**FINAL MITIGATION PLAN**  
**MIDDENDORF SPRINGS MITIGATION SITE**  
**ANSON COUNTY, NORTH CAROLINA**

DMS Project No.100151  
DWR Project No. 2020-0775v1  
NCDEQ Contract No. 8012-01  
USACE Action ID No. SAW-2021-01973

Re: NCIRT Review and USACE Approval of the NCDMS Middendorf Springs Mitigation Site /  
Anson County

Re: DMS Project ID # 100151 / Middendorf Springs Stream and Wetland Mitigation Site Mitigation Plan  
IRT Comments

C-16

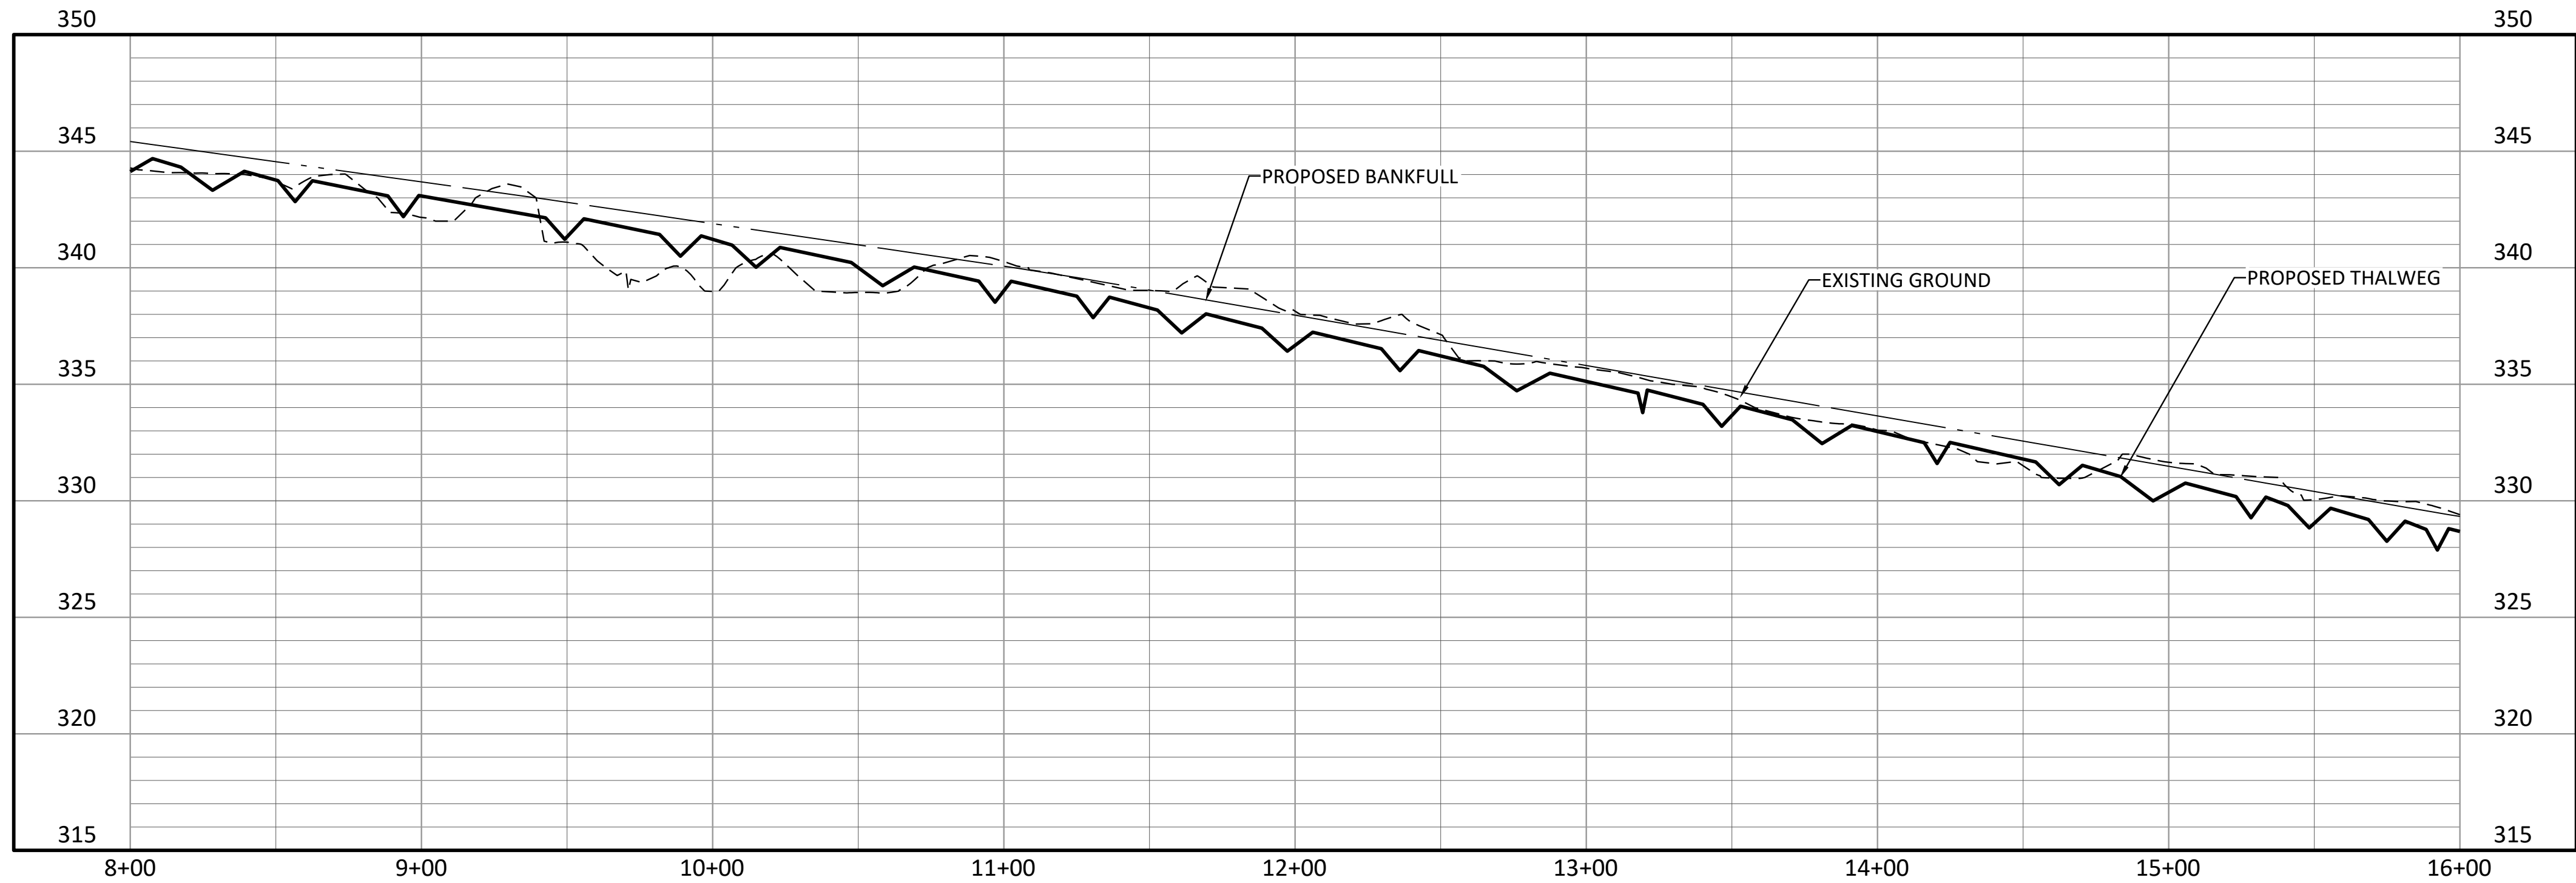
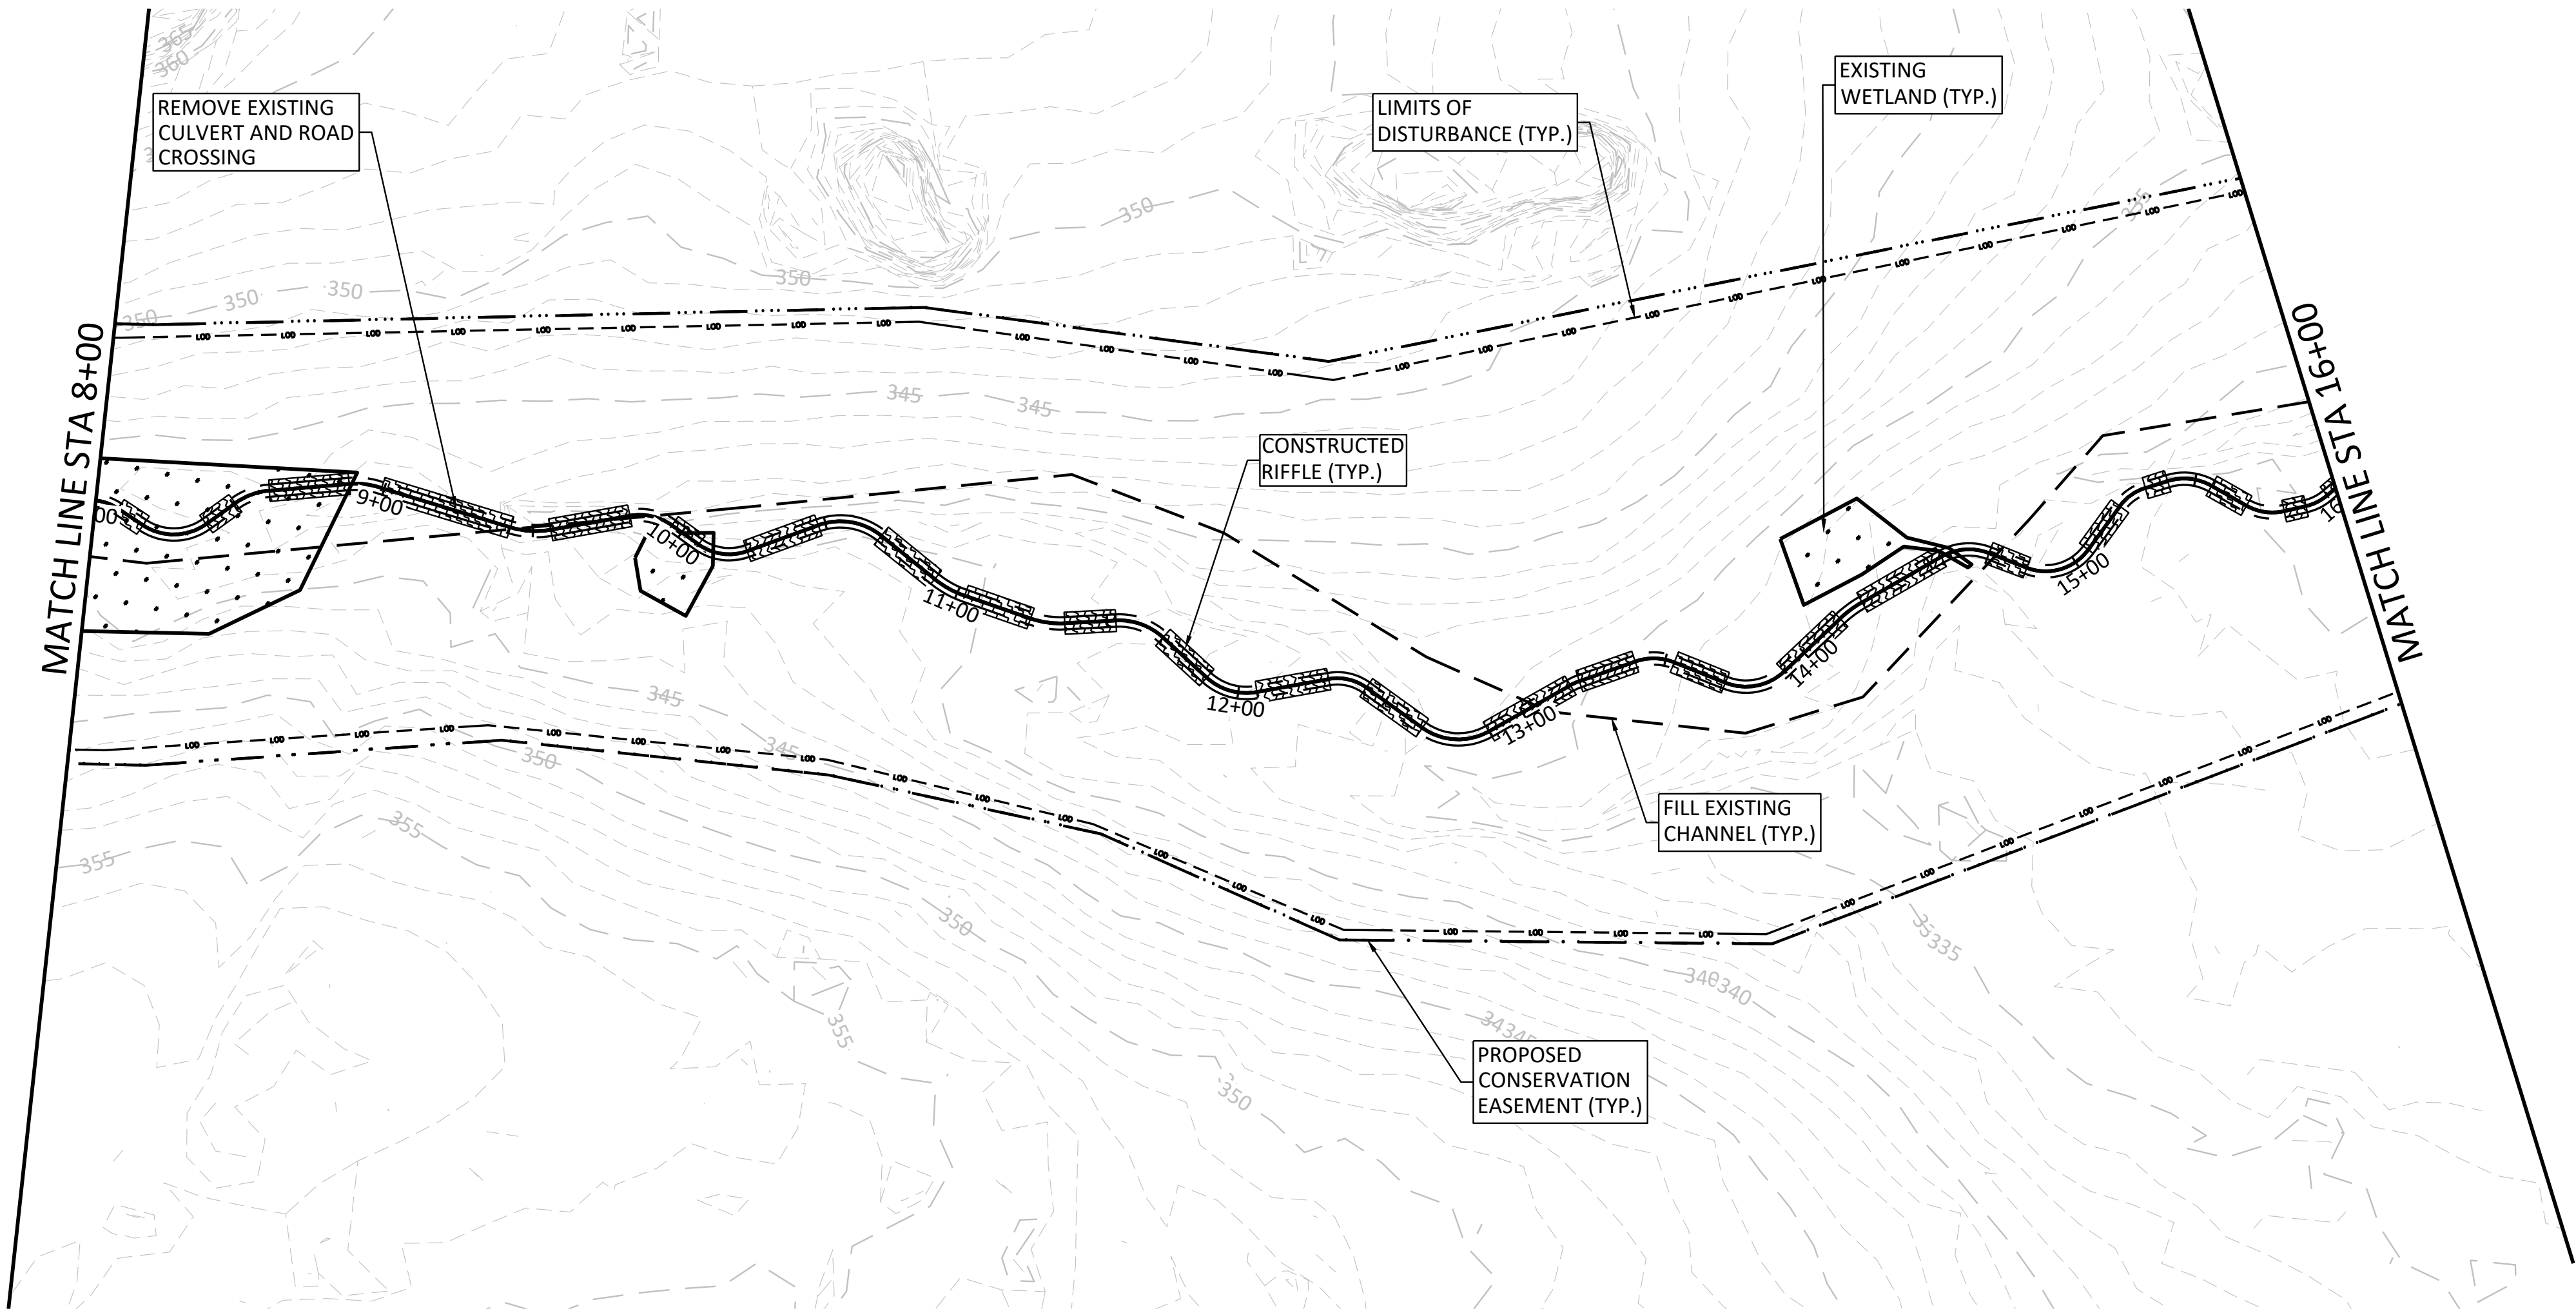
- 15. Design sheet C16- DWR requires a gauge stream right at approximately station 4+50.**

Comment noted and we will add a stream gauge to the mitigation plan at that location.

1  
DT-3  
ANGLED LOG SILL ROLLER  
NOT TO SCALE

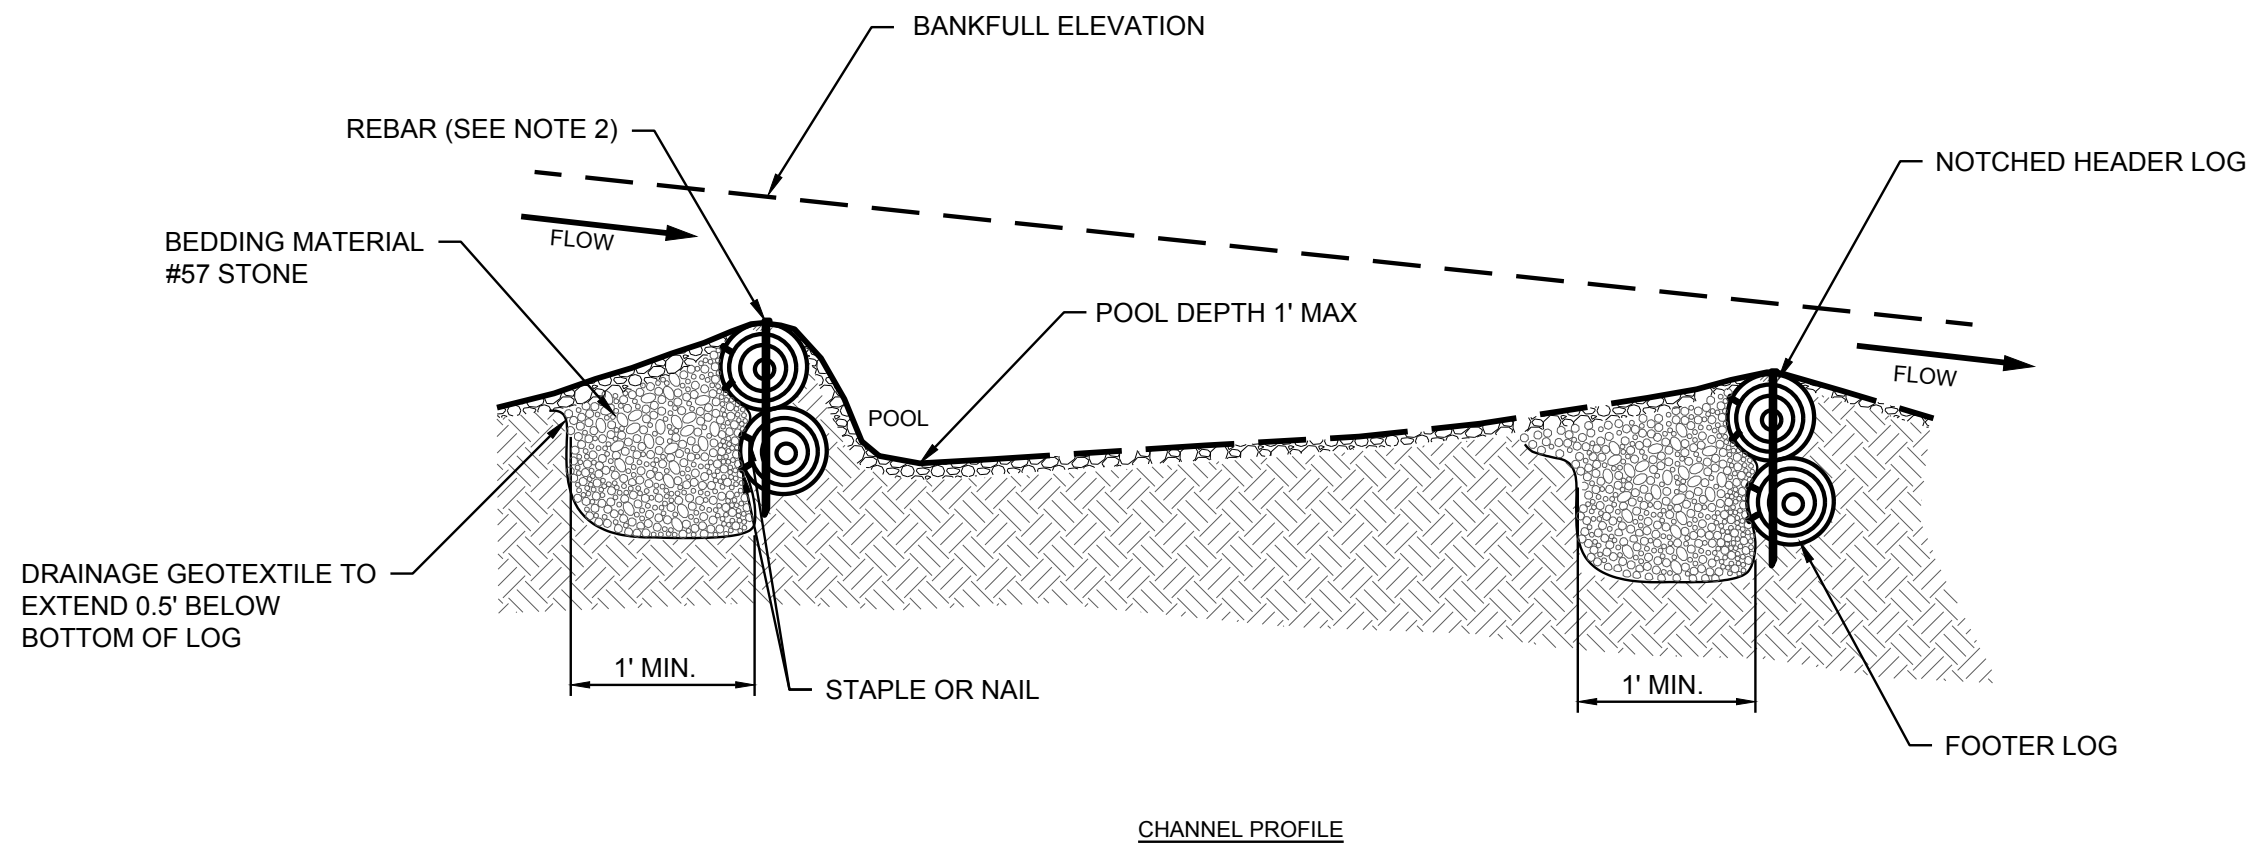
- 16. Design sheet DT3 – DWR requests the on-site construction supervisor emphasize the specs of the log sill rollers with the construction company and specifically emphasize placement, footer logs and the minimum amount of length the log embedded into the bank.**

See response to DWR Comment #2 where we attempt to address all of DWR's concerns about angled log sills. We will emphasize the requested items with the construction contractor.
